Local Planning Panel 1 July 2020

160B Glebe Point Road, Glebe

D/2020/18

Adaptive reuse of a terrace as a five room, seven person boarding house and associated alterations

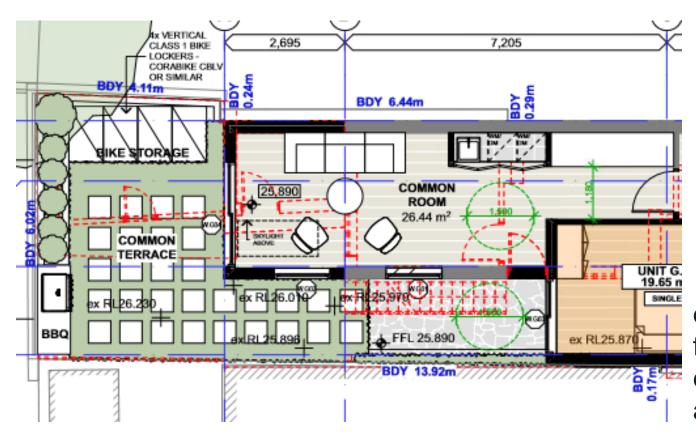
conditions recommended to address treatment of façade
